Microsoft Ireland
Proposed Modifications to Previously Approved Scheme
Reg. Ref. SD20A\0283
(Proposed Central Administration Building,
2 No. Data Centres and Ancillary Works)

Grange Castle Business Park

Planning Submission
Architects Design Statement
AR-001 -A

June 30th 2021

Fig. 29 Proposal Description – Key Plan (image updated)

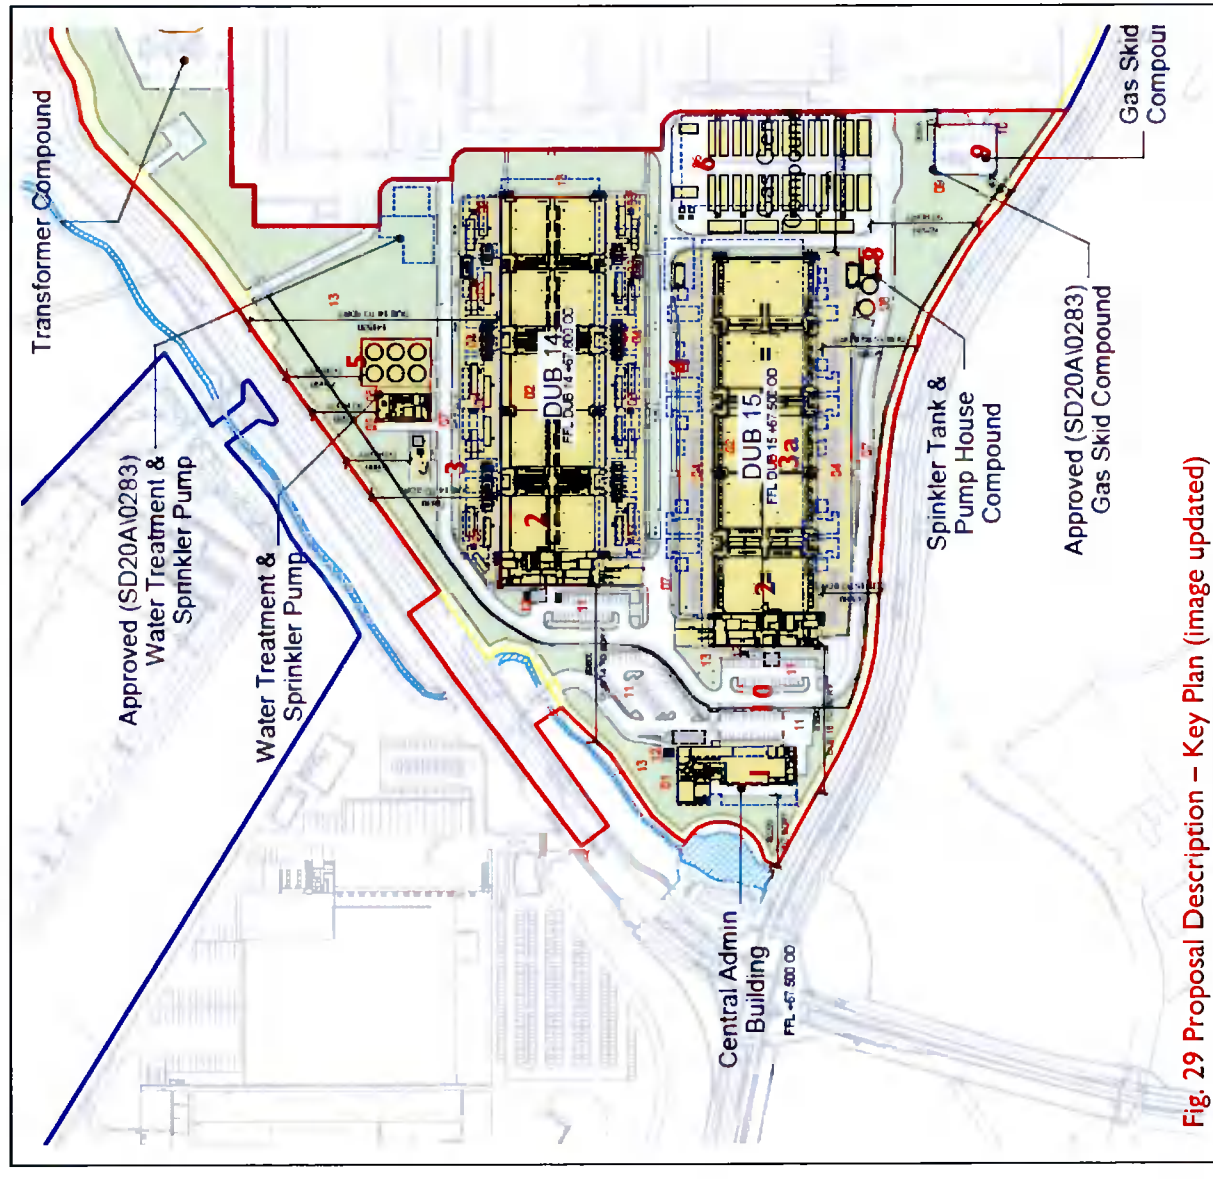
Microsoft Operations Ireland Ltd is applying for PERMISSION for modifications and minor additions to previously approved scheme (Planning Register Reference SD20A\0283). The development will comprise the following changes to previously approved scheme SD20A\0283:

- 1 **Approved Central Administration Building (CAB):** Proposed relocation of building to the east by approx. 7m. Proposed reconfiguration and setting out of building plans at all levels (including roof level) resulting in increase in building footprint of approximately 170m² (from 1,424m² to 1,594m²) associated changes to building elevations (design and finishes).

- **Approved single-storey Cafeteria Element:** Proposed additional basement level below cafeteria to accommodate plant, proposed 9 no. rooflights (2.8 m diameter) and 9 no. rooflight (1.8m diameter), inclusion of MEP Plant on roof level including new flue extending approx. 1m above parapet.

- 2 **Approved Data Centres – DUB14 and DUB15:** Proposed reconfiguration and setting out affecting building locations and plans at all levels (including roof level) resulting in reduction in overall building footprint (for each building) by 48m² (from 13,442m² to 13,394m²), associated changes to staircases design, building elevations (design and finishes). Increase in parapet height of Vent Houses (at roof level) by approx. 350mm and omission of previously proposed zone of sedum roof finish. Overall decrease in GIFA of 1,352m² in respect of DUB 14 and decrease of 1,453m² in respect of DUB 15. All plant equipment at ground level - reduced in height compared to approved layout so that the screening is deemed not required

- 3 **DUB 14:** Reduction in height of approved flues by approx. 650mm, reduction in number of flues from 11 no. approved to 8 no. proposed
 - 3.a) **DUB 15:** Change to level of ground floor and associated increase in overall building height of approx. 700mm (parapet height increased from approved +83.0m O.D. to proposed +83.7m O.D.).

- 4 Reconfiguration of **associated external plant** at ground level (including generators / E-Houses & transformers) flues, omission of approved Modular Electrical Rooms (MERS) and associated screening serving approved Data Centres DUB14 & 15.

- 5 Relocation, modifications to design and expansion of approved **Water Treatment Building and associated plant** to include:
 - 4 no. Water Treatment Tanks, 2 sprinkler tanks and relocated approved pump house (contained in the main Water Treatment Plant building) and 1 generator with additional proposed flue stack (height 30.75) and 1 no. transformer.

Fig. 30 C.A.B. Proposed Basement Plan (image updated)

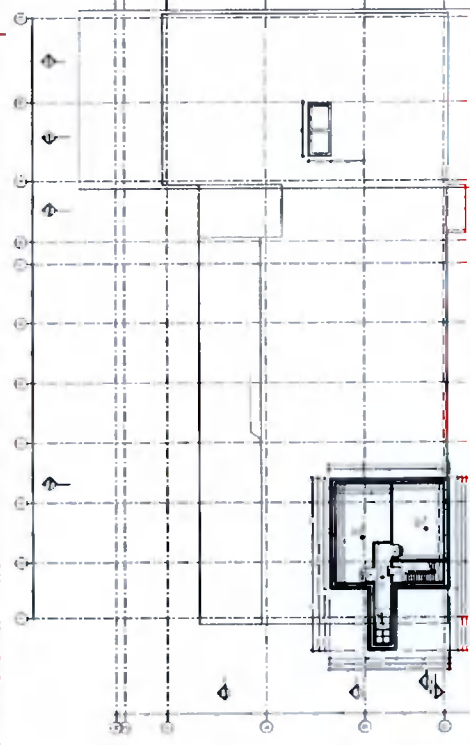
- **Basement Level**
 - Additional Basement level to accommodate additional plant space.

Fig. 31 C.A.B. Proposed Ground Floor Plan (image updated)

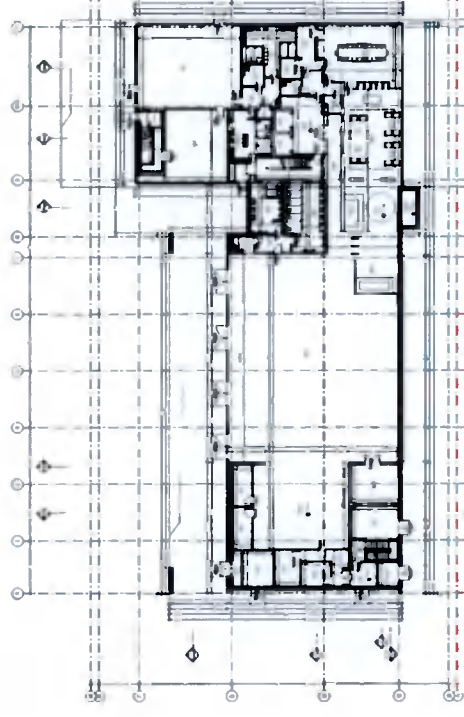
- Cafeteria building footprint extended south to accommodate additional plant space
- Relocation of kitchen/B.O.H. areas to provide improved servicing and realignment of elevations to suite
- Extended cafeteria area at the centre of the volume
- Partial infill of indent between office and Cafeteria to relocate toilet block
- Stair blocks relocated to optimize escape routes and connections.

Fig. 32 C.A.B. Proposed 1st Floor (& Cafeteria Roof) Plan (image updated)

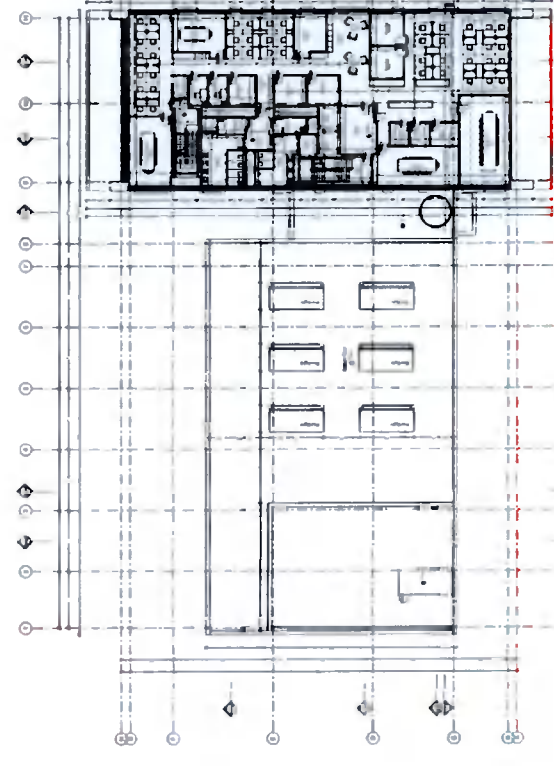
- Reduced Green Roof area to allow for skylights above cafeteria with the goal to provide additional natural light to the space
- Increased MEP terrace area
- Flue extending approximately 1m above parapet level

Fig. 33 C.A.B. Proposed Ground Floor Plan (Level 01) (image updated)

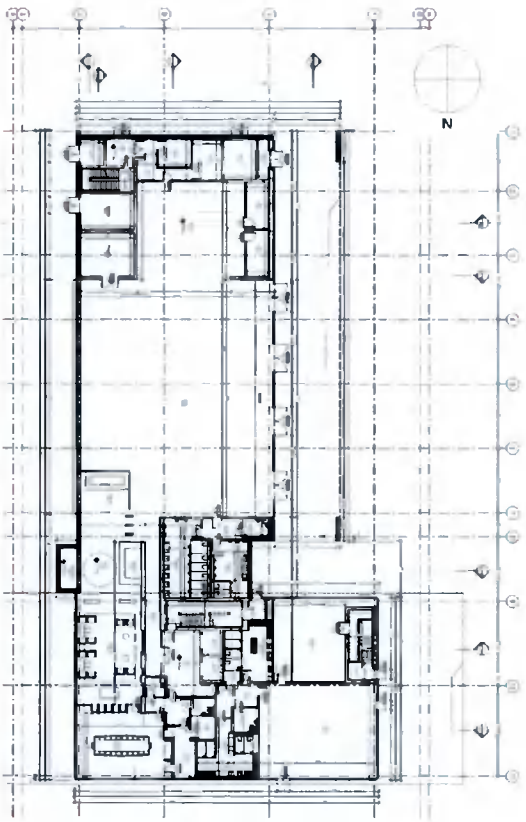
- Overall Modifications**
- Relocation of core resulting in realignment of glazing to office building
 - Projecting envelope to East and West gables of Office building reduced by 0.5m.
- Ground Floor (Level 01)**
- Entrance lobby layout revised
 - Overall footprint extended to the west beneath the office floor plate zone

Fig. 34 C.A.B. Proposed 1st Floor Plan (Level 02) (image updated)

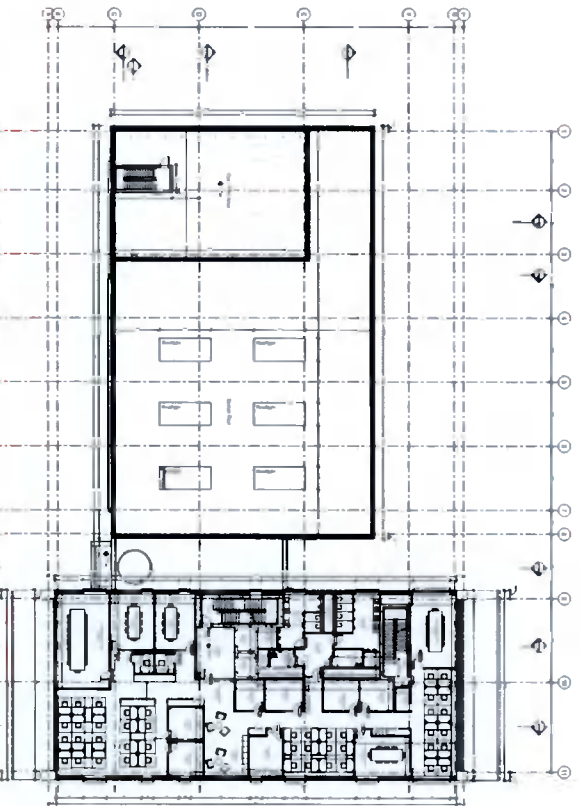
- Level 02**
- Relocation of core resulting in realignment of glazing to office building
 - Projecting envelope to East and West gables of Office building reduced by 0.5m.

Fig. 35 C.A.B. Proposed 2nd Floor Plan (Level 03) (image updated)

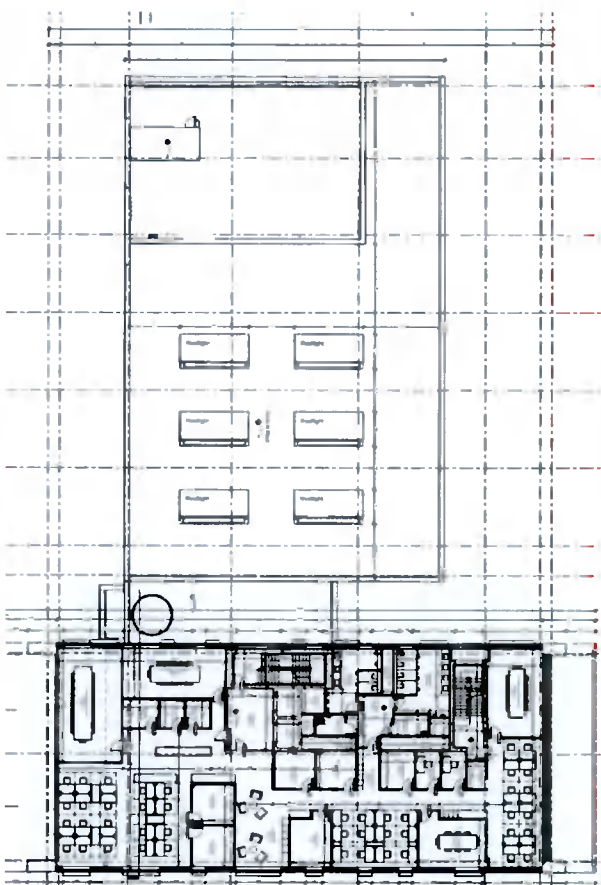
- Level 03**
- Relocation of core resulting in realignment of glazing to office building
 - Projecting envelope to East and West gables of Office building reduced by 0.5m.

Fig. 36 C.A.B. Proposed 3rd Floor Plan (Level 04) (image updated)

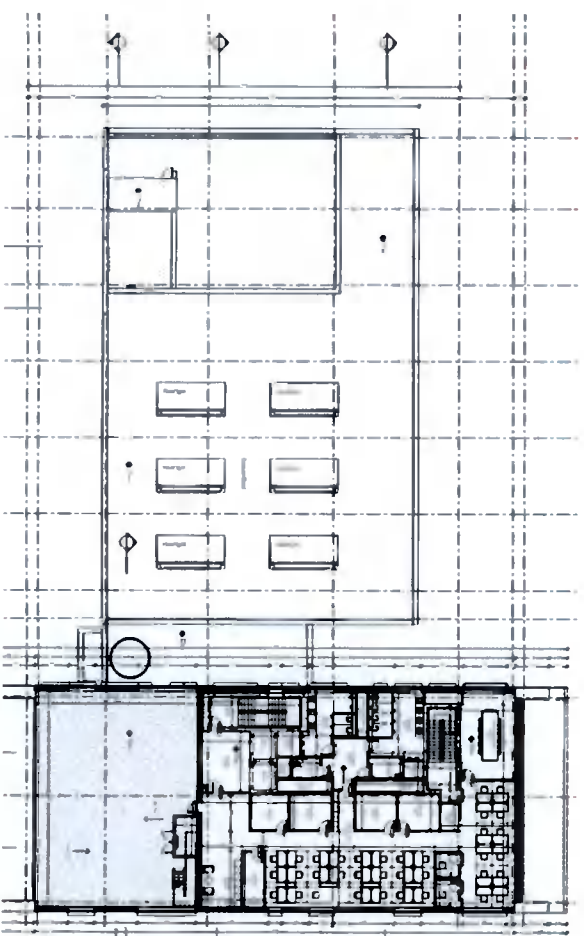
- Level 04**
- Relocation of core resulting in realignment of glazing to office building
 - Projecting envelope to East and West gables of Office building reduced by 0.5m.

Fig. 37 C.A.B. Proposed Roof Plan (image updated)

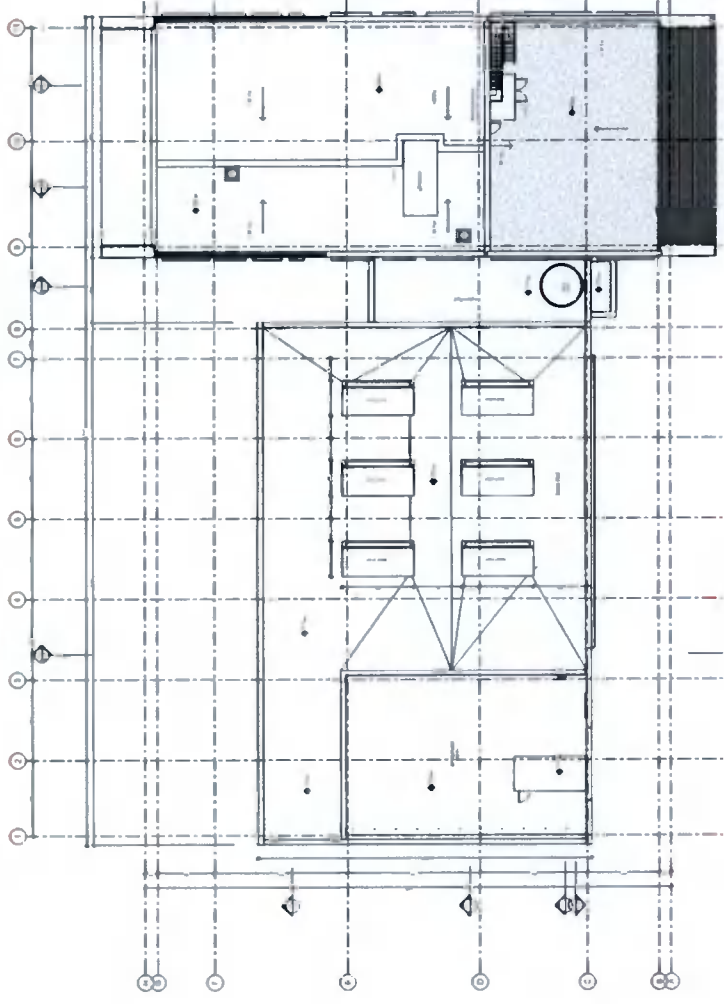
Roof Level
- PV panels area revised (reduced in area) to cater for additional MEP equipment

FIG. 40 CENTRAL ADMINISTRATION BUILDING – SECTION THROUGH OFFICE ELEMENT

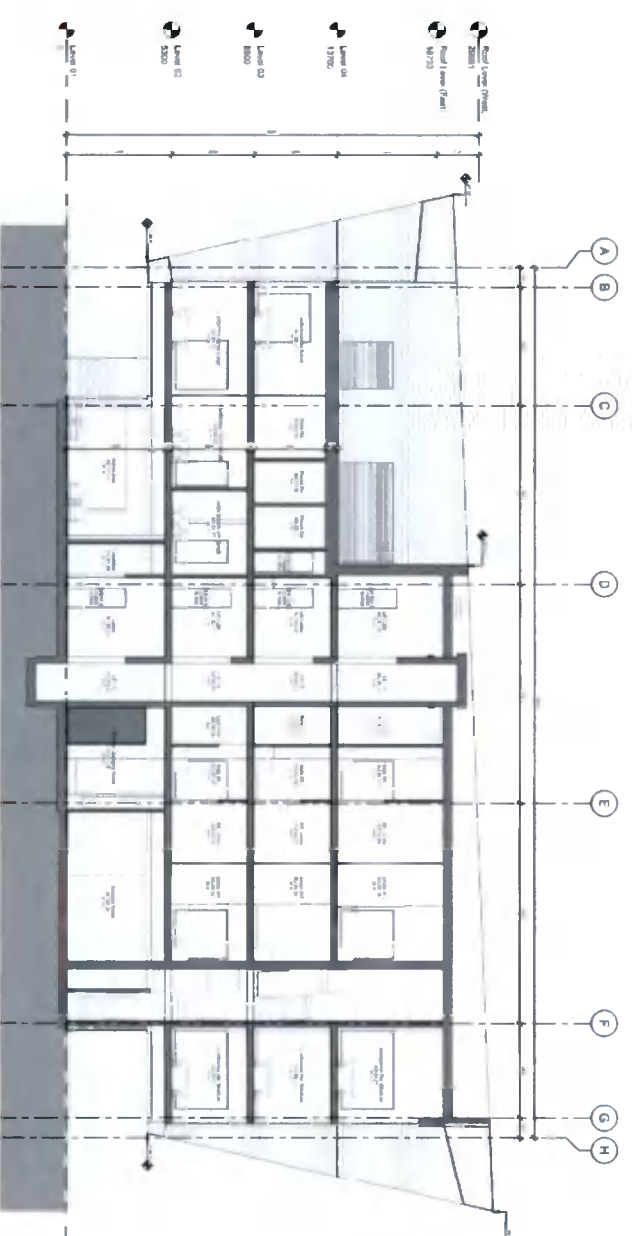
The building's height varies across the three elements of its composition. The parapet height of the approved four-storey office element was approximately 19.5m above ground level, the revised proposed maximum height has increased by approximately 1.1m to 20.6m above ground level (an increase of approximately . The staff cafeteria wing has an angled roof height and the massing of this element is designed to reduce down from the higher scale of the four storey office block to a more human scale closer to the public realm of the Nangor Road and landscaped wetland area to the west of the site.

The office element has a 2.7 m floor to ceiling height (floor to floor height of 4.2m) whereas the ground floor has a more generous floor to ceiling height of 4 m. The section conceals the external roof plant element.

The proposed maximum height of 89.4 O.D. is well below the maximum permissible height within the Baldonnell Aerodrome Secure Flight Zone of 98.00 O.D.

FIG. 41 CENTRAL ADMINISTRATION BUILDING – SECTION THROUGH OFFICE ELEMENT (Image updated)

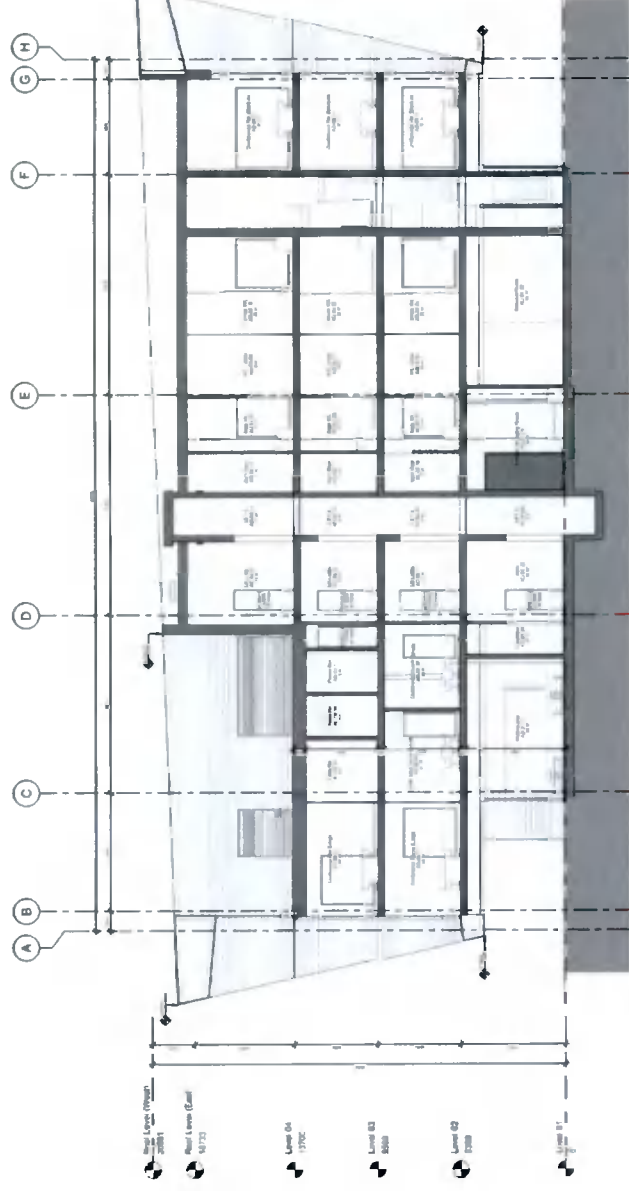
The proposed Cafeteria Plant Area has been moved to the South side of the roof so that it benefits from higher screening at the building side and plants are better connected to the equipment rooms at the ground floor.

FIG. 50 DUB 14 – GROUND FLOOR – DESIGN MODIFICATIONS – Outline of Approved Layout indicated with blue broken line for comparison purposes.

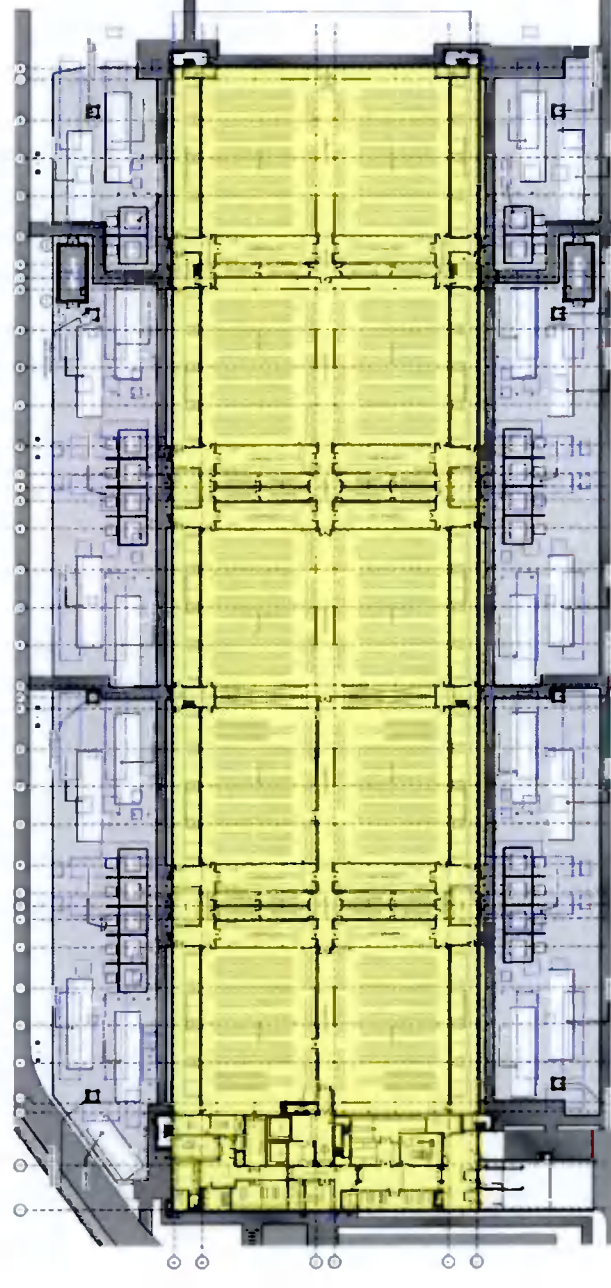
All plant equipment at both DUB14 and DUB 15 ground floor electrical compound has been revised and updated. The updated equipment has a lower impact on the elevation visuals particularly when viewed from the public domain (e.g. from the Nangor Road in the case of DUB 15)
